MAGNA ✓ CHEK ^M

SUBJECT: Control Number 77973 - Additional information to Amendment to License Number 21-19111-02 per telephone request by John Madera, USNRC, on April 25, 1985.

FIGURE 1
EXPOSURE CELL

FIGURE 7
EXPOSURE CELL

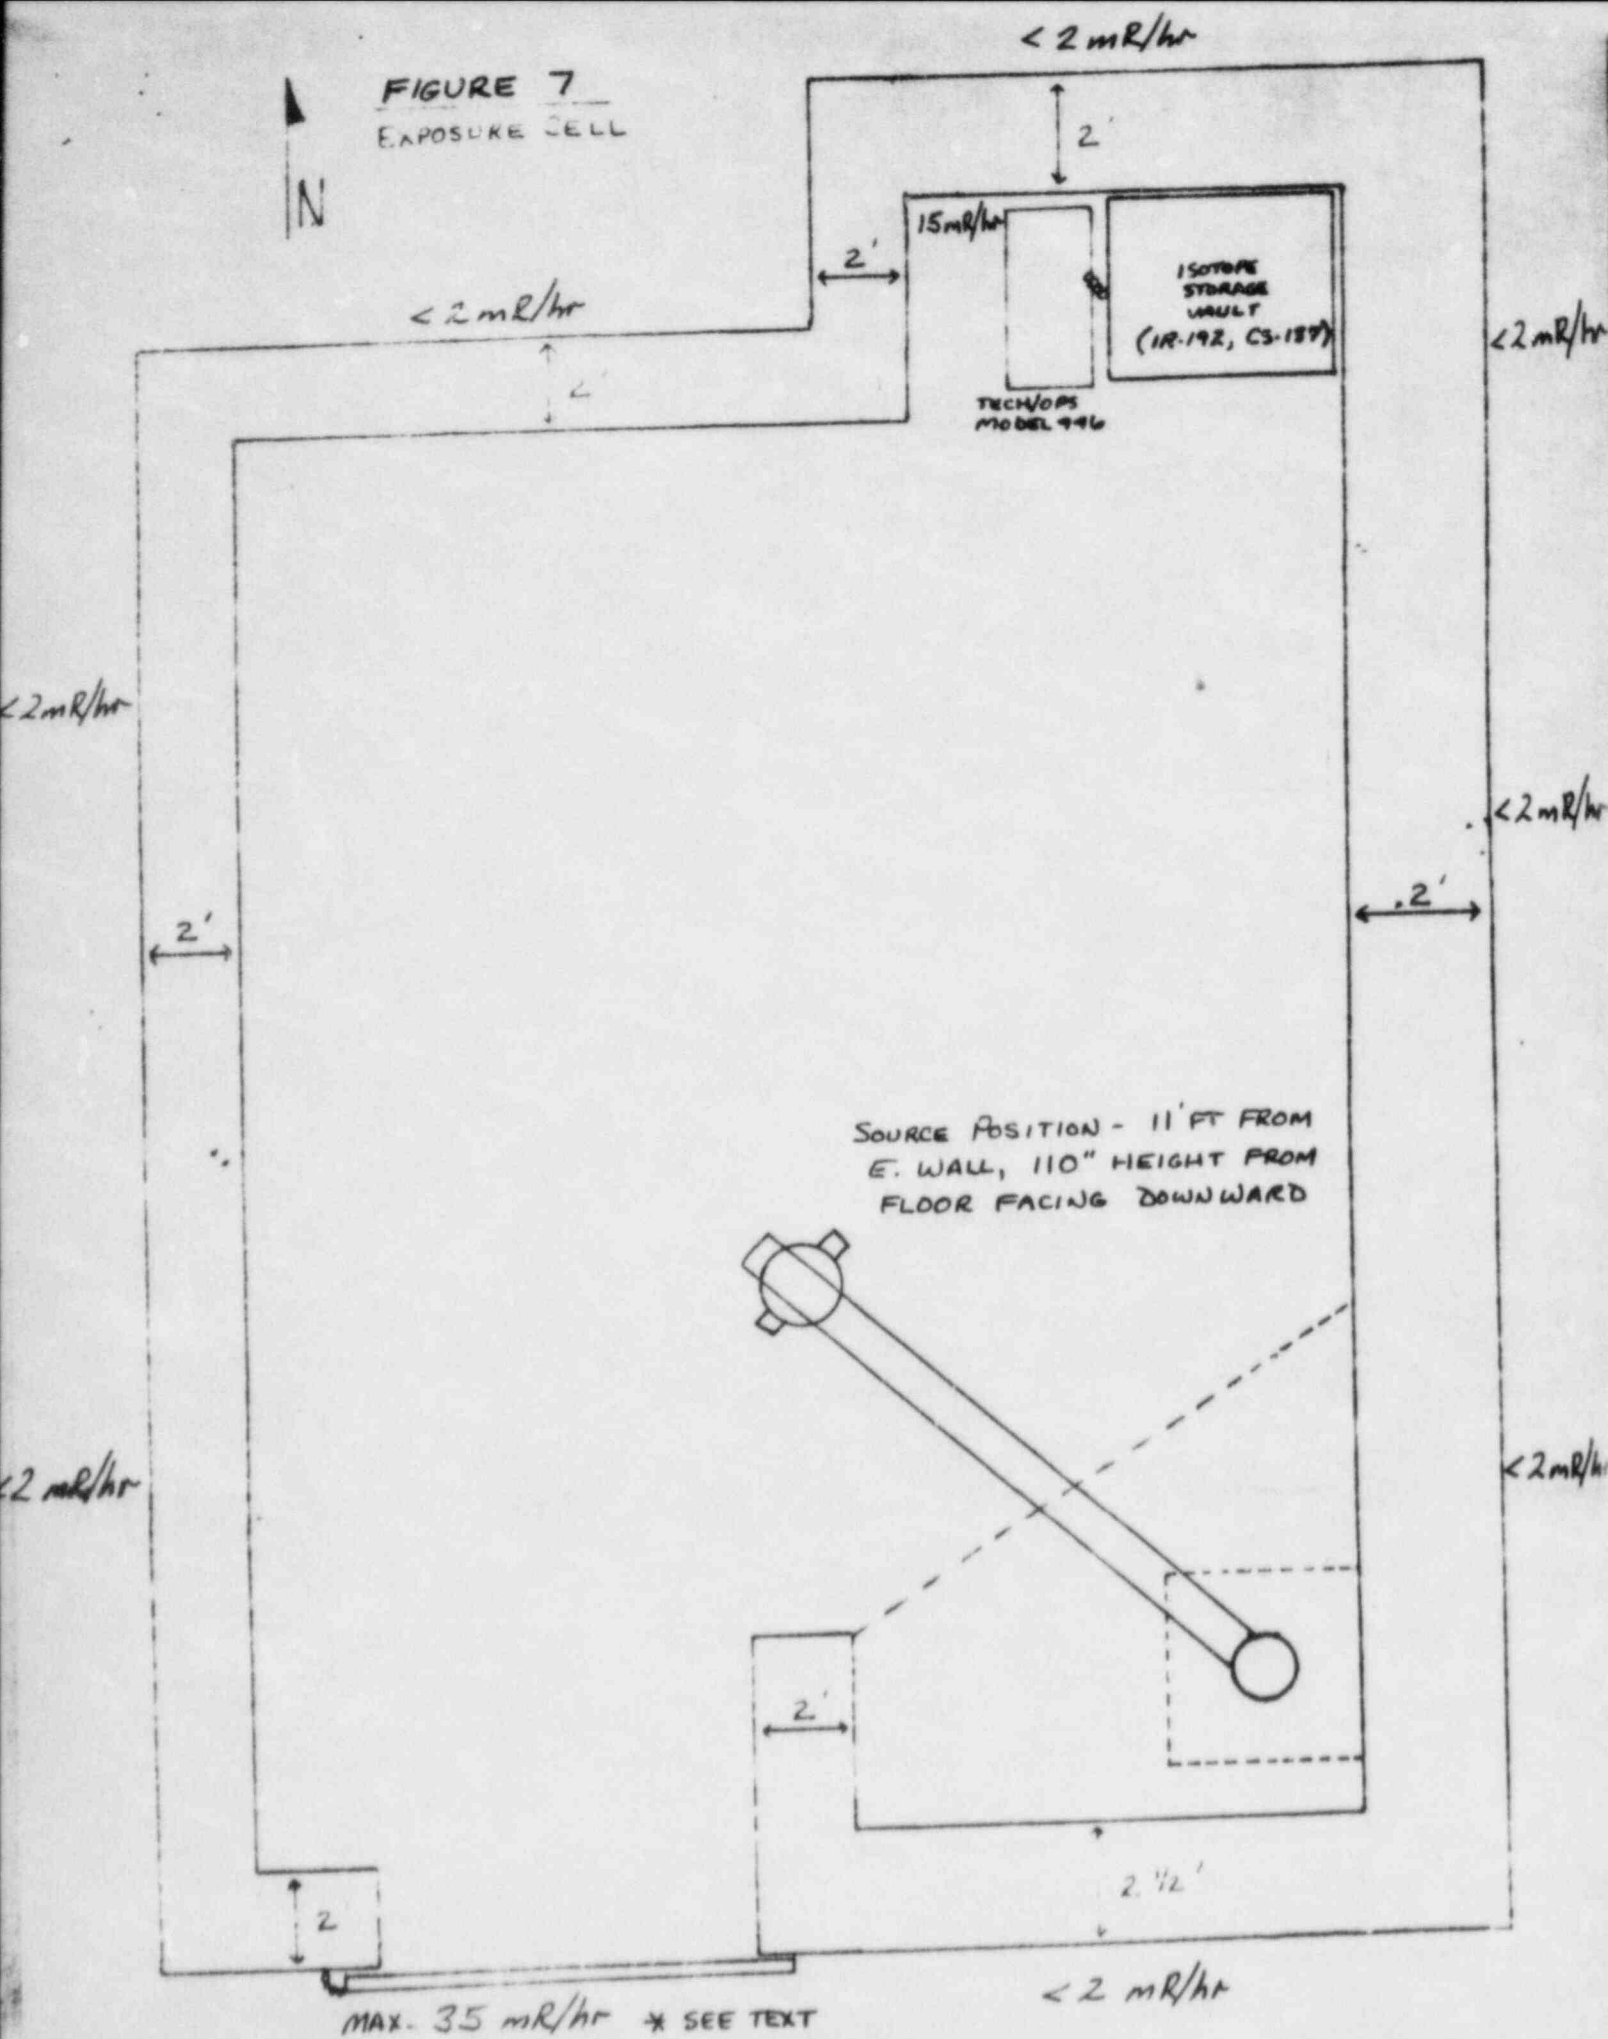
- Figure 7 - Surveys indicated that radiation levels at external surfaces of the exposure cell did not exceed 2 mR/hr except for the exposure cell door which was 35 mR/hr. When levels of this intensity are present, the restricted area boundary is adjusted to reflect a 2 mR/hr intensity as shown in Figure 14.

FIGURE 8
EXPOSURE CELL

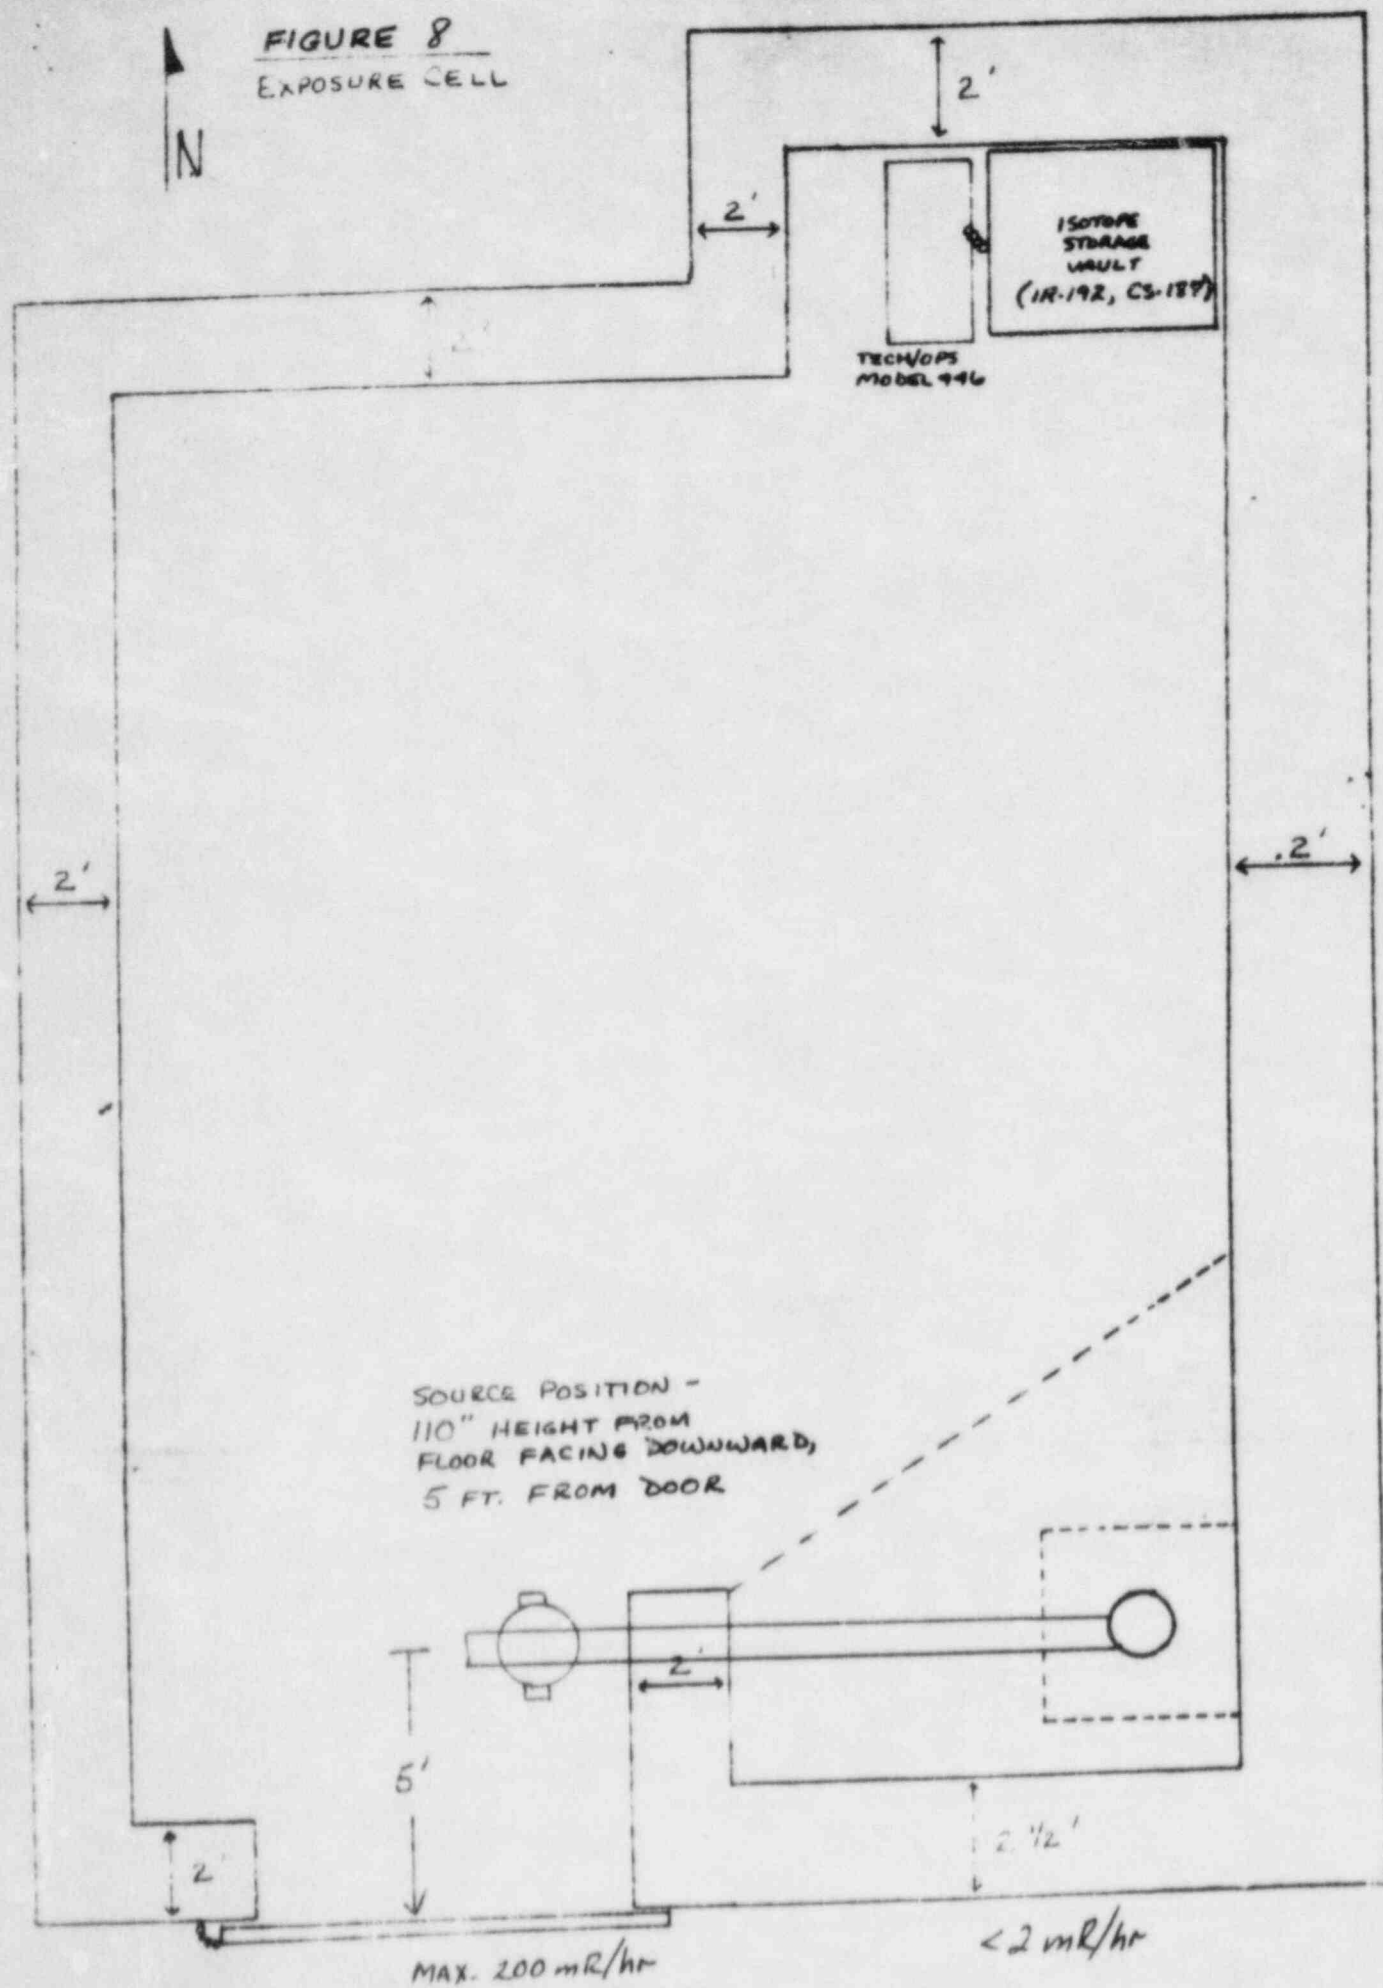
- Figure 8 - With the source positioned in the downward position only 5 feet from the exposure cell door, radiation levels were found not to exceed 200 mR/hr at the door due to the effects of the collimator. The source is not used in this position.

FIGURE 9
EXPOSURE CELL

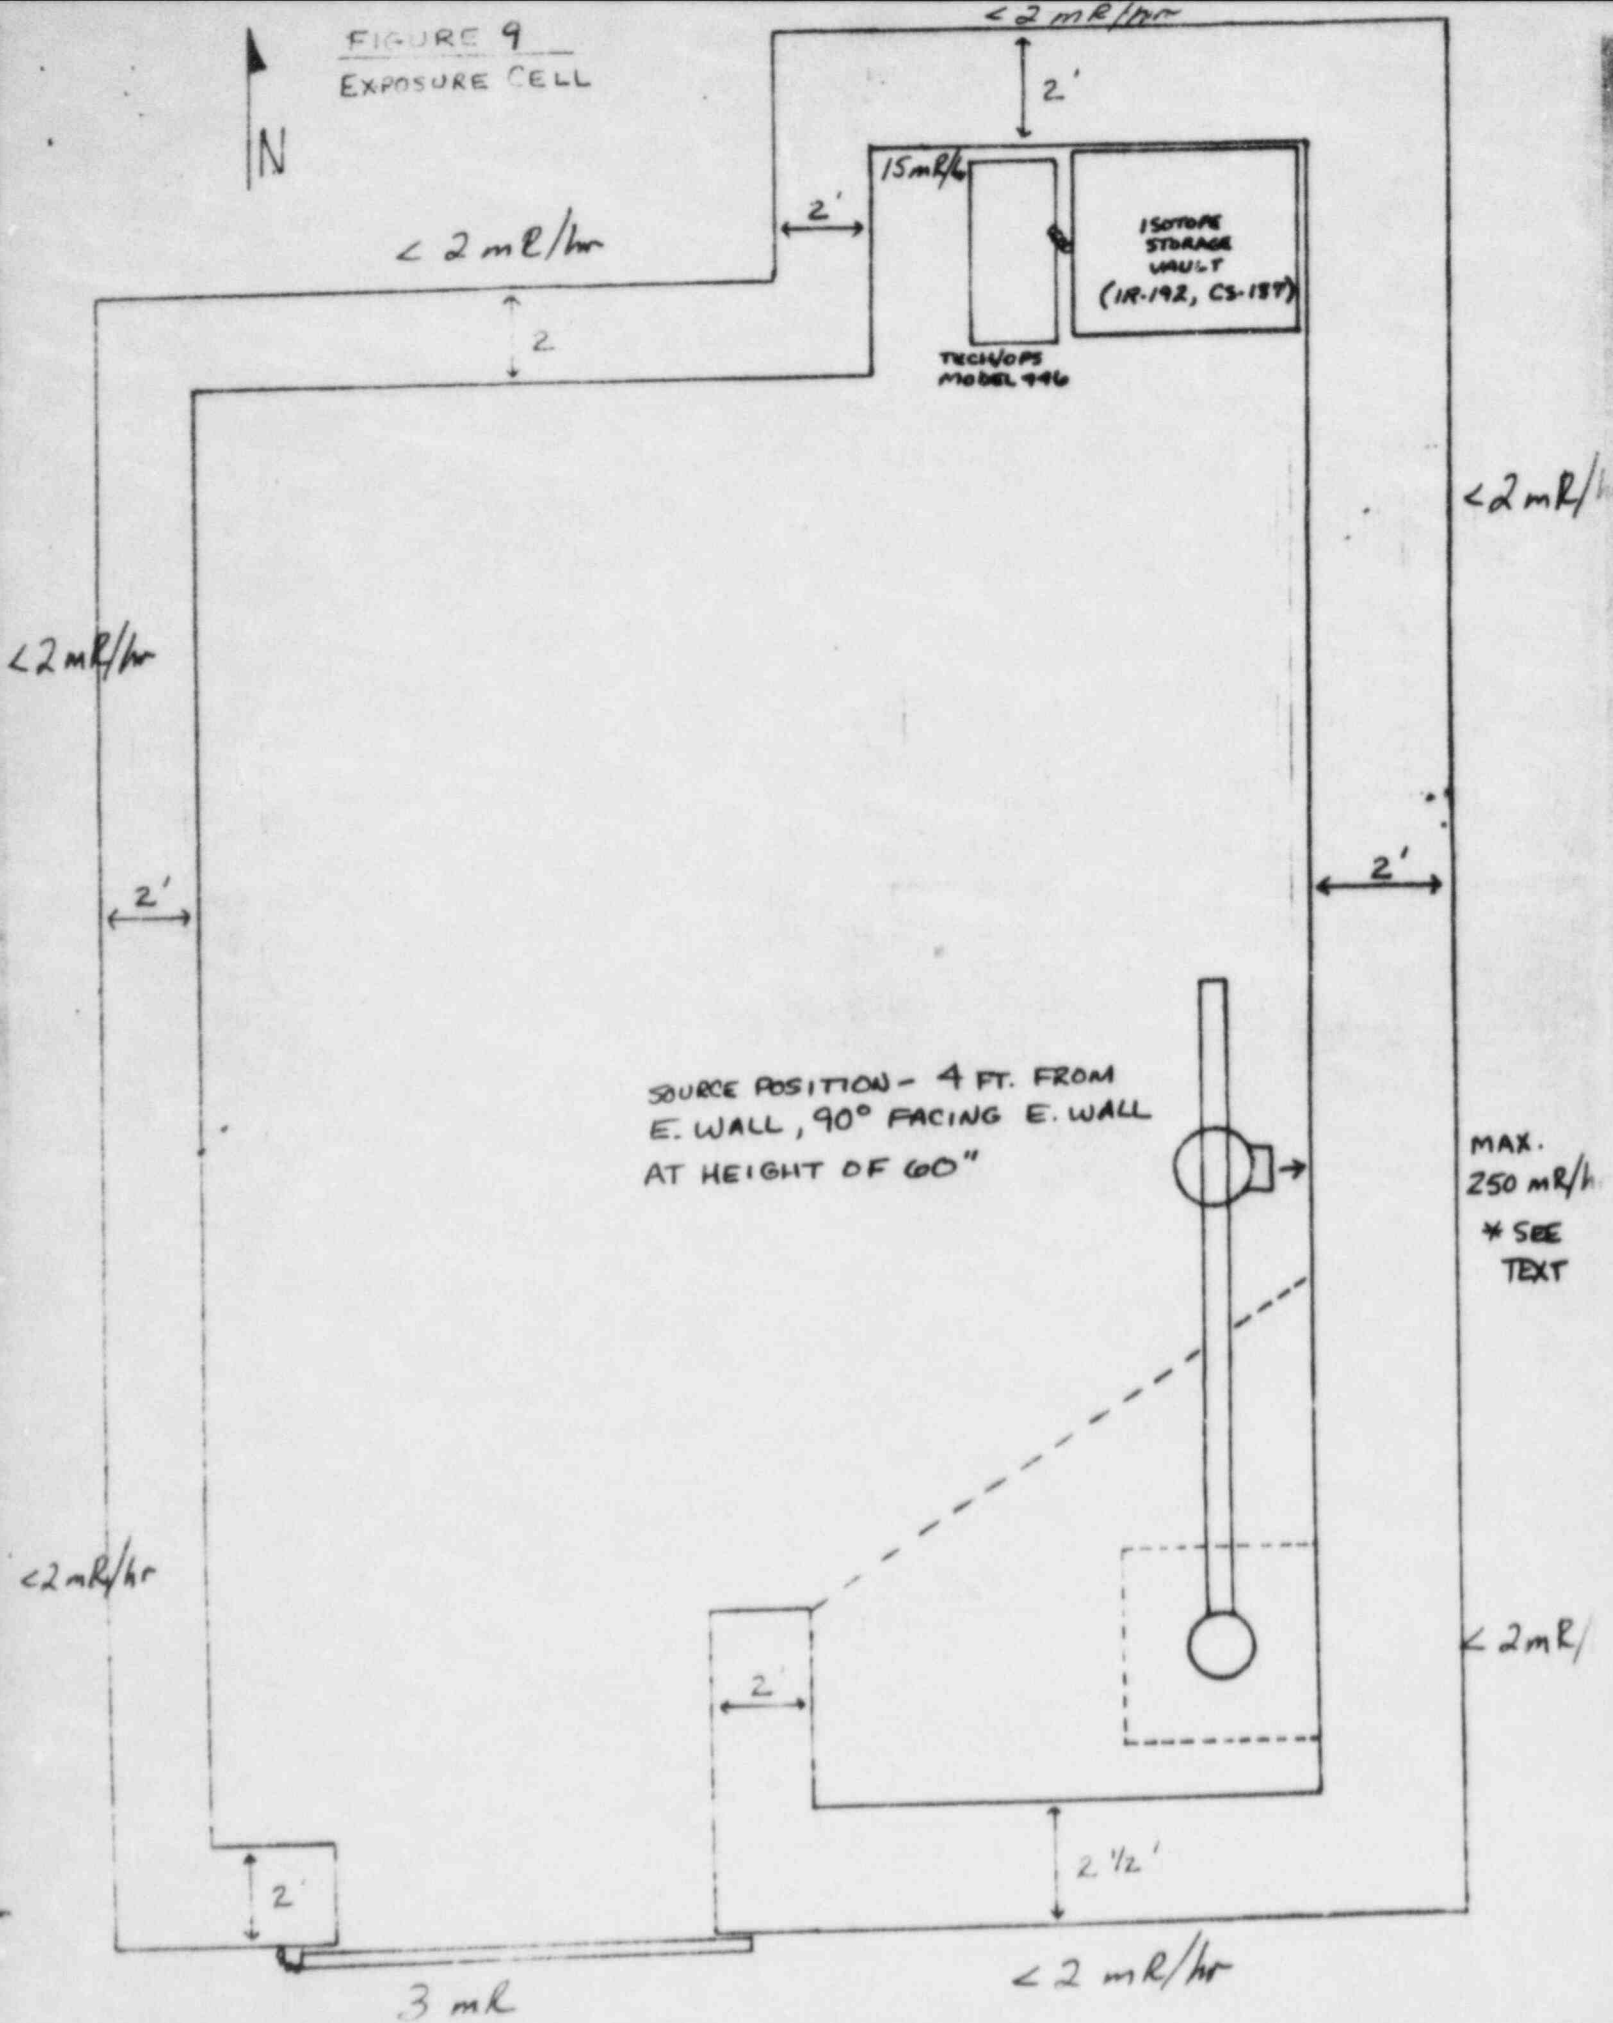
Figure 9 - With the source positioned directly at the east wall at a distance of 4 feet, surveys indicated that radiation levels at external surfaces of the exposure cell did not exceed 3 mR/hr except at the east wall where the intensity was 250 mR/hr. The source is not used in this position.
